BULLETIN: BU-134 MC

ROUND-UP/PARATROOPER MAIN SPINDLE SHAFT SAFETY LIMITING RING

BULLETIN: BU-136 MC

ROUND-UP/PARATROOPER HUB INSPECTION

| CENTER HUB ASSEMBLY | | | |

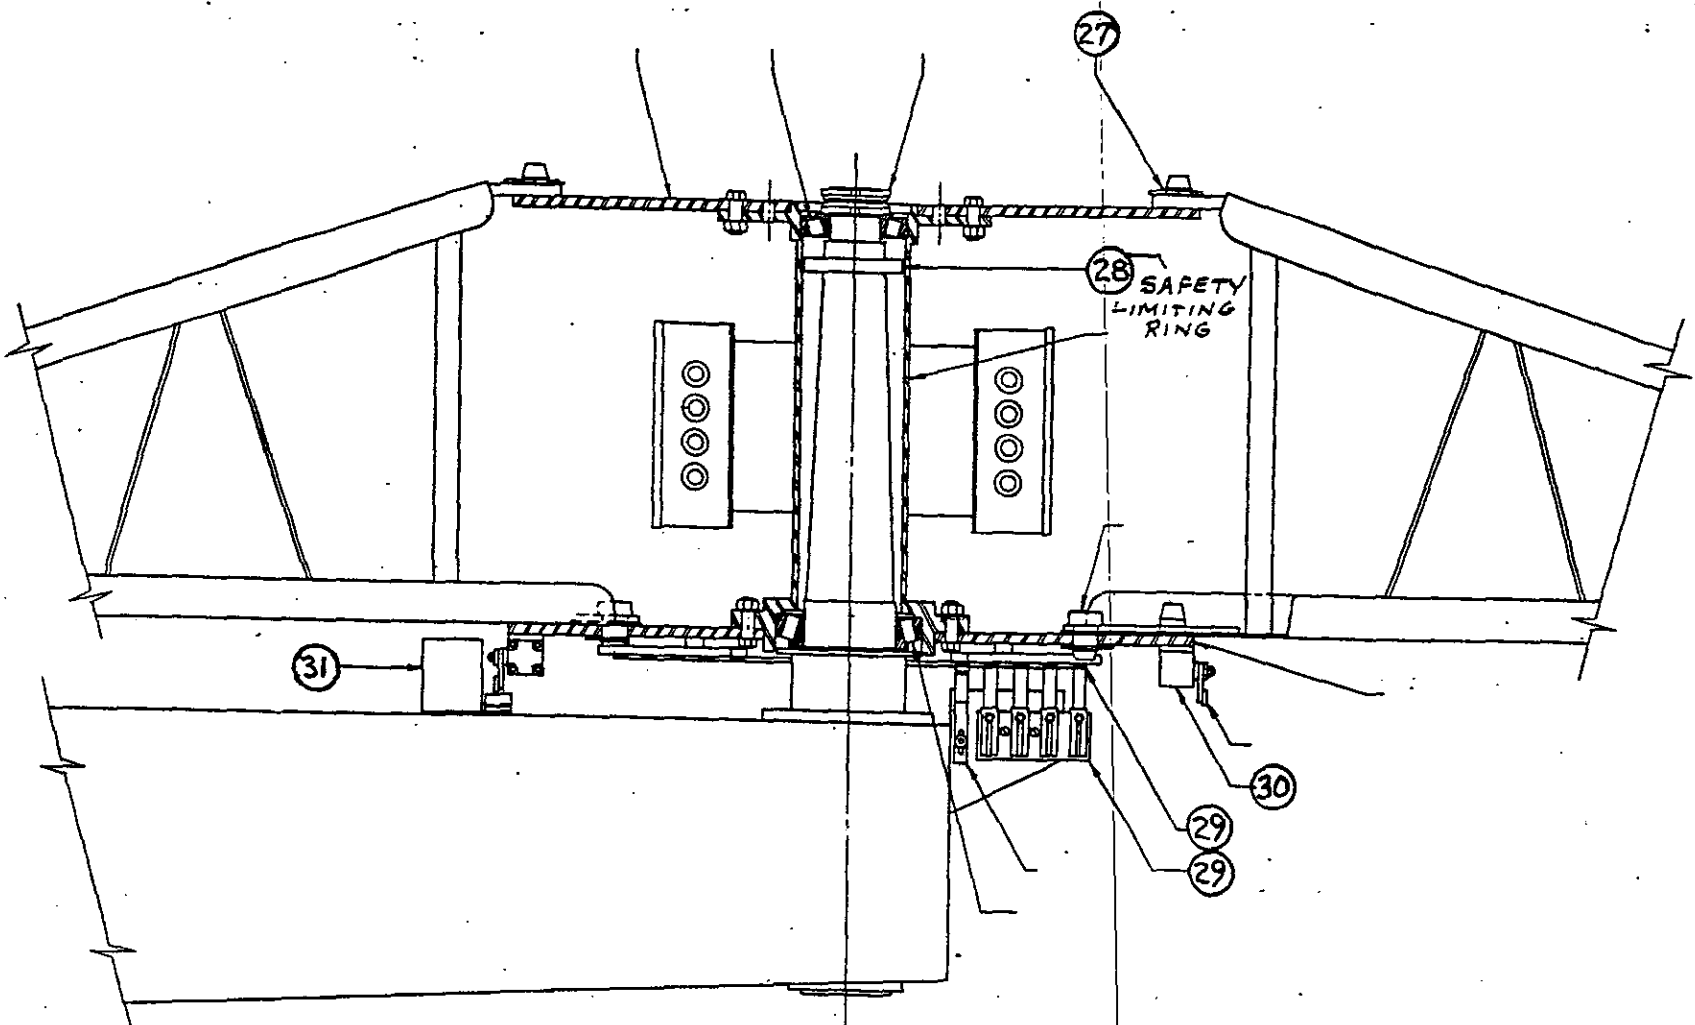
A Round-Up manufactured by Frank Hrubetz & Co., Inc. has experienced a failure in the upper bearing in place on the main spindle. When this happened, support at the top of the spindle was lost making it possible for the rotating platform to tilt and contact the main boom.

This condition makes it possible for the pins and sweeps to hit the boom and bring the rotating platform to a sudden stop.

1. Remove the center ornament and inspect the weld on the hub (shown in drawings RD-35R and FR-503S) for cracks. If there are cracks, ship the hub to Man-Co Mfg.. We will repair, using the design presently being used.
2. Remove the top bearing and visually inspect the bearing and make sure there is a safety limiting ring in place. If there is a limiting ring on your ride, it will be plainly visible on the upper portion of your main spindle shaft. If it is not present, we highly recommend that you add this part immediately. (Part #STD 353)

CENTER HUB - INSPECTION OF WELDS

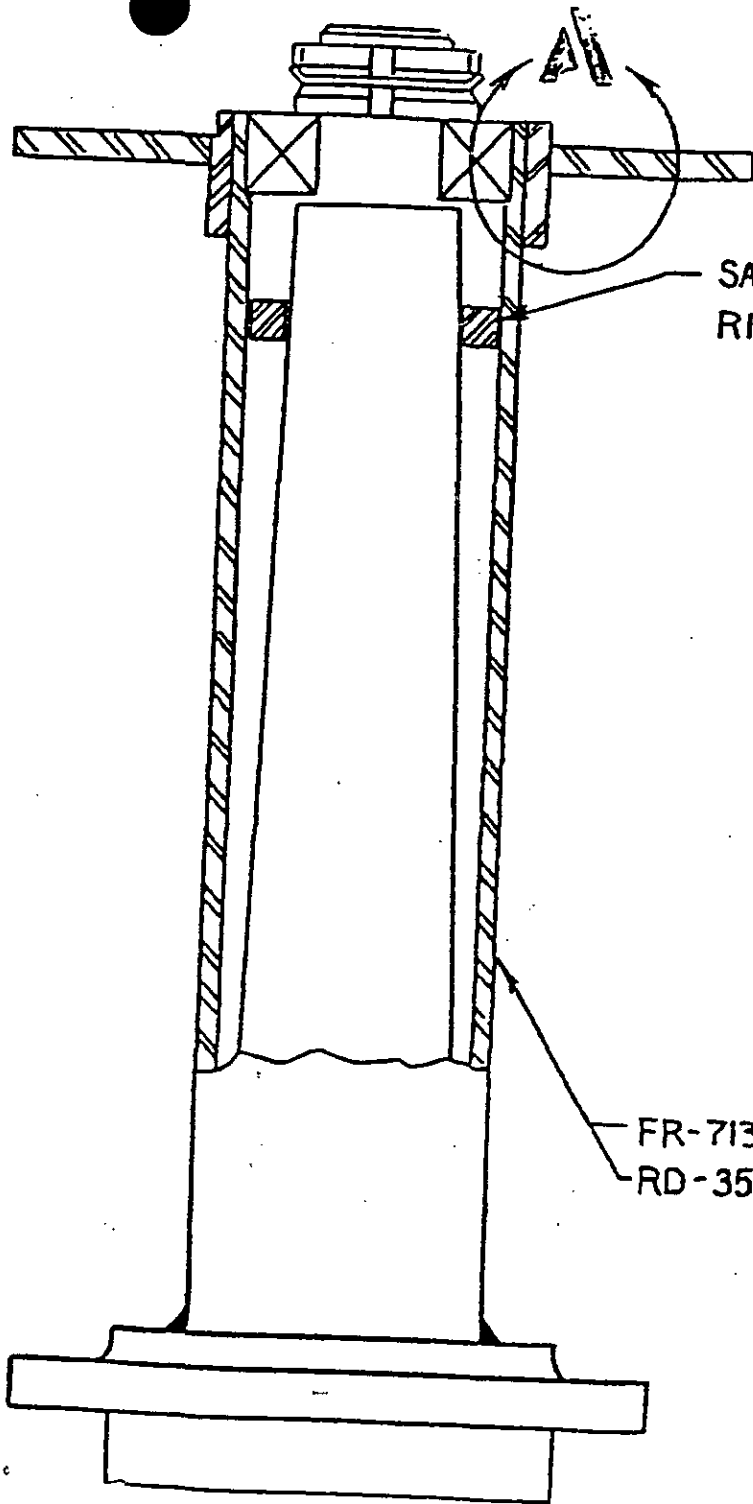
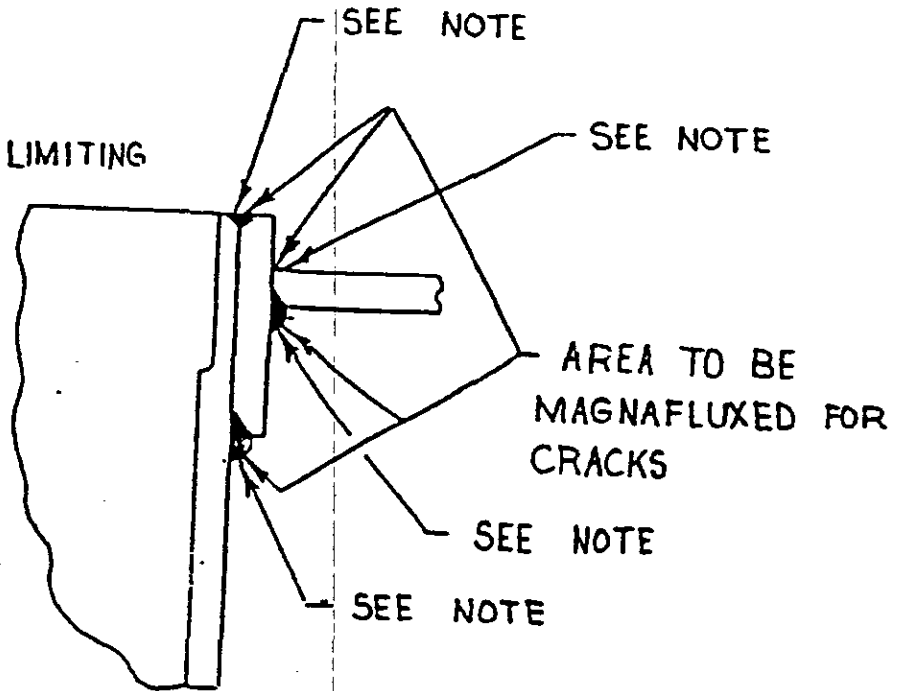
The main spindle shaft hub housing on the Round-Up and Paratrooper amusement rides that were manufactured by Frank Hrubetz Co., and Kilinski Mfg. Co. (KMC) have shown some sign of fatigue cracks in the weld areas of the hub assemblies.

We at Man-Co feel that this is something that should be inspected on a more regular basis and so we are recommending that the welds shown in the attached drawing (BU-136-MC) be inspected annually. If any sign of stress or cracks are noted, then we recommend that the entire hub assembly be replaced for the safety of the ride owners and customers.

AREA TO BE MAGNAFLUXED FOR CRACKS

IF CRACK IS
NOTED IN THIS
AREA, CENTER HUB
SHOULD BE REPLACED

| SPINDLE SHAFT ON BOOM | | HYD. PART |

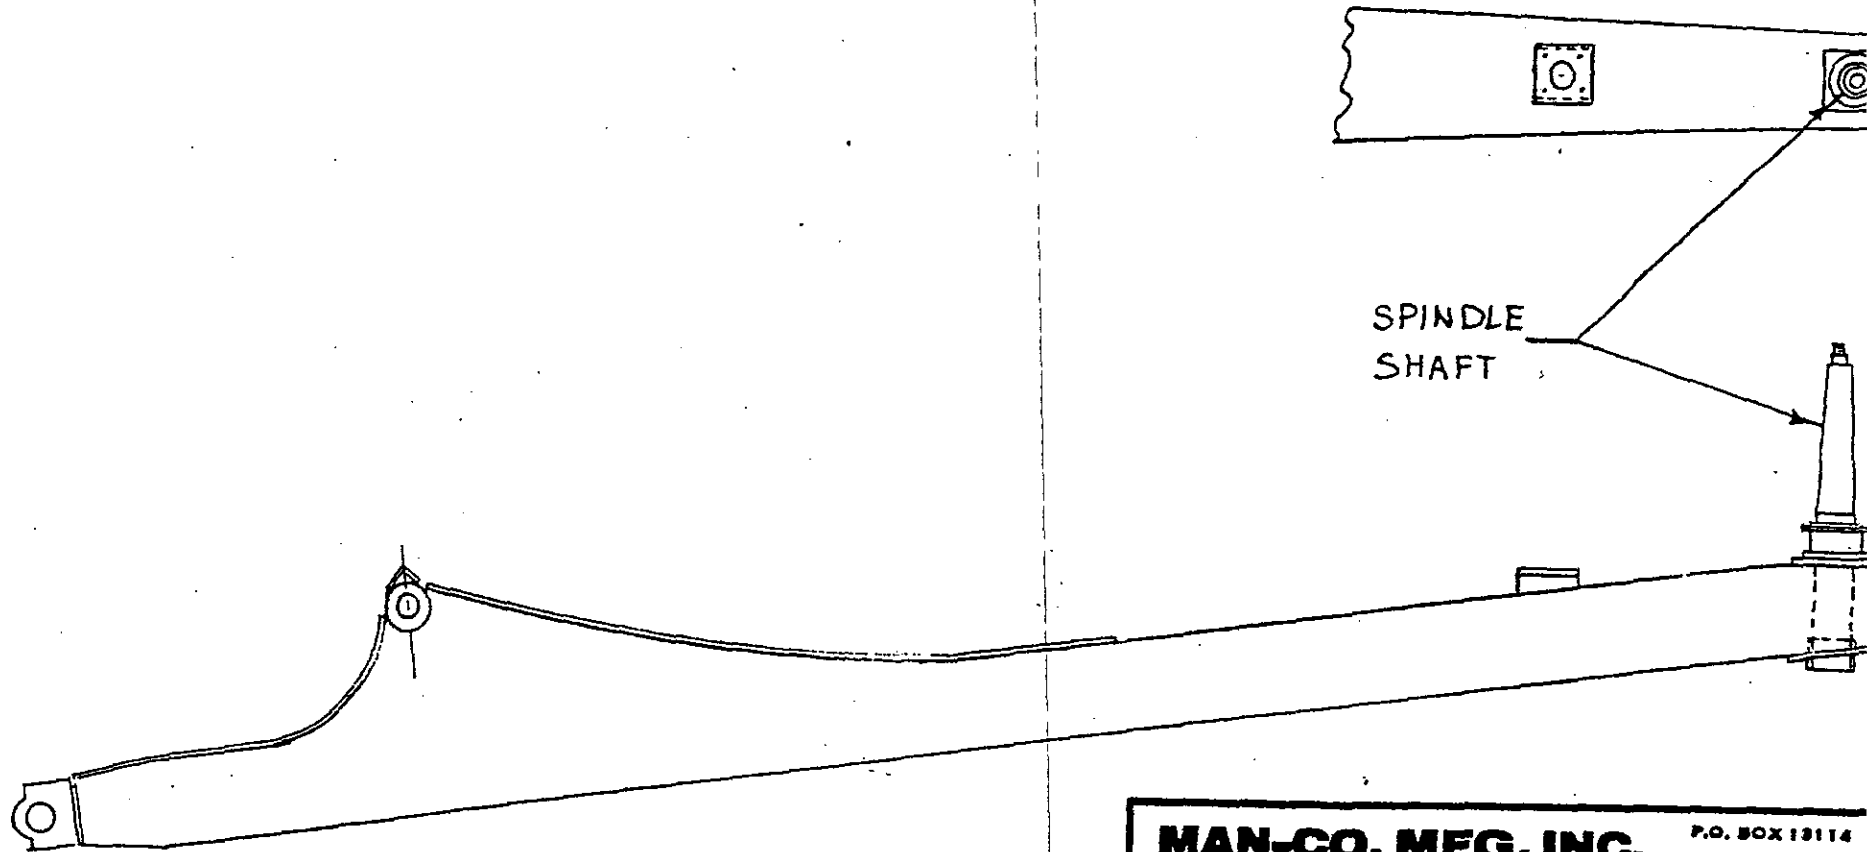
It has been brought to our attention that there have been recent failures of the shafts and spindles of the above mentioned rides that were manufactured by Frank Hrubetz Co. and Kilinski Manufacturing Company (KMC). For various reasons, these failures have only occurred in those rides that have the shafts and spindles welded directly into the boom. Newer rides and replacement shafts and spindles that have used shrink collars for installation (therefore no direct welding to the shaft) have not experienced these failures and with proper maintenance and regular testing should provide years of safe operation.

- 1) Inspect your ride and determine if the shafts and/or spindles are welded in directly, or if shrink collars are used. (See Drawings BU-138-A through F for information on how to determine the installation method used on your ride.)
- 2) If shrink collars are used on your ride, there is no need for replacement. Please note: All shafts and spindles still need to be tested annually according to the procedures outlined in BU-135-MC (QC-UI-1 - Rev. 3).
- 3) If the shafts and/or spindles on your ride are welded directly to the boom, then replacement is needed.

Due to the time element involved to manufacture and install these shafts and spindles, we recommend that a time period of one year be allowed to make these replacements. However, if your ride is a 1970 model or older, we recommend the replacements be installed as soon as feasibly possible.

30' FOLDING ROUND-UP ANCHOR SHAFT

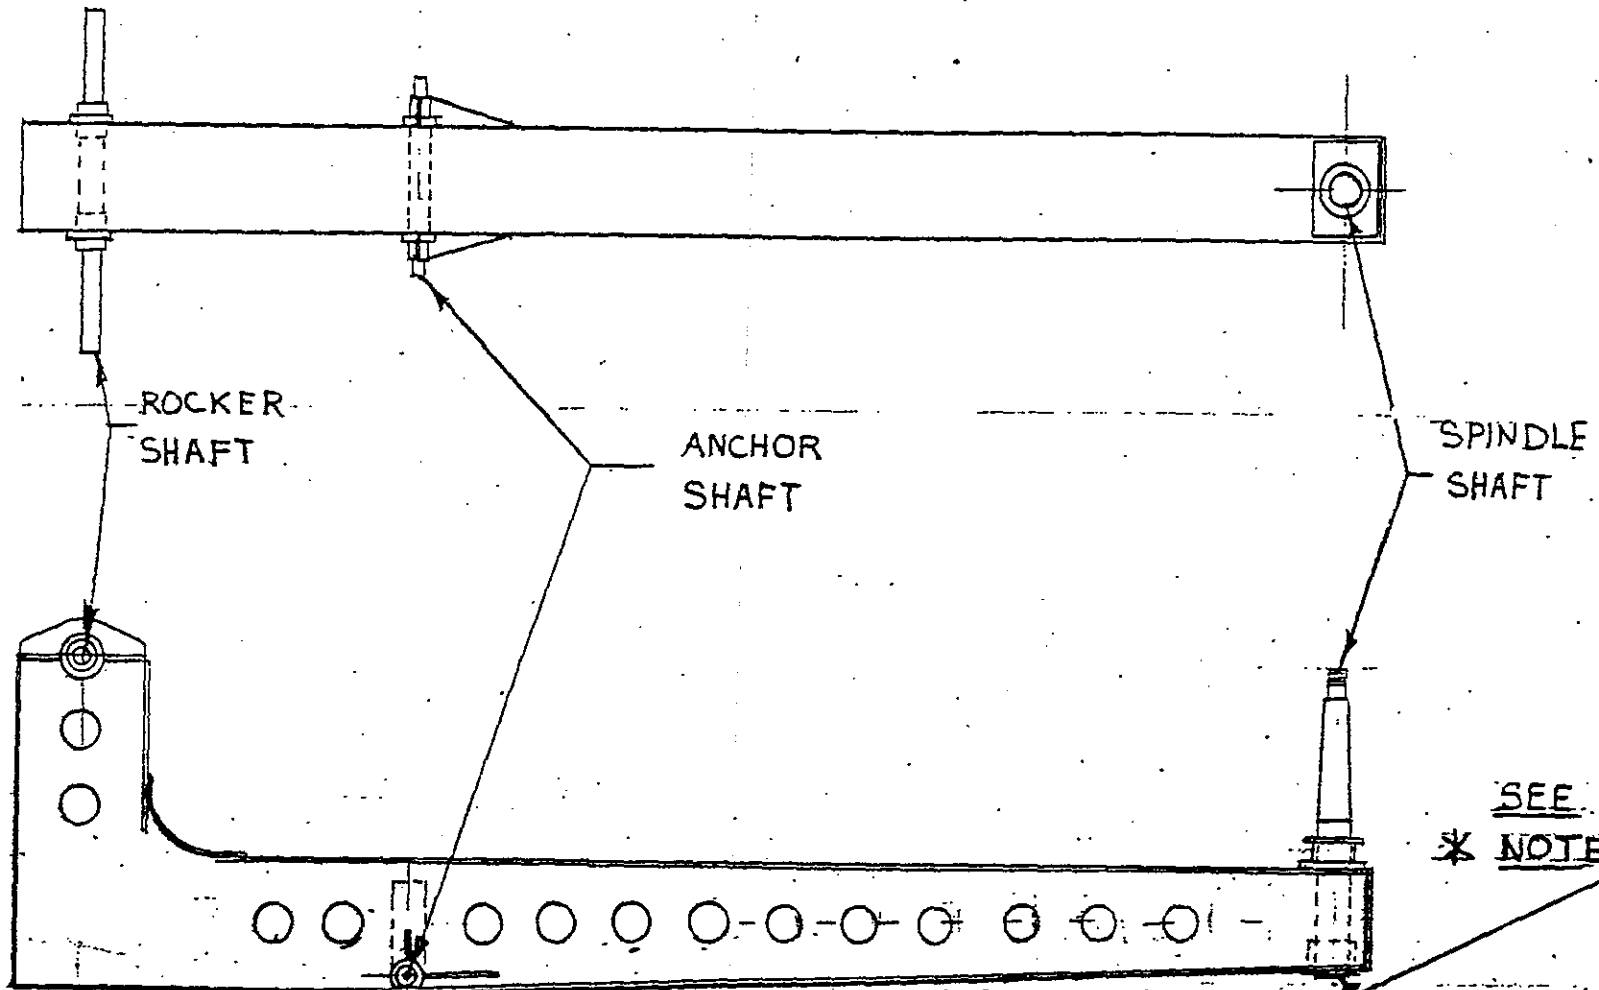
*NOTE: IF NO SHRINK COLLAR IS VISIBLE AT BOTTOM OF BOOM, THEN REPLACEMENT OF SPINDLE SHAFT IS NEEDED.
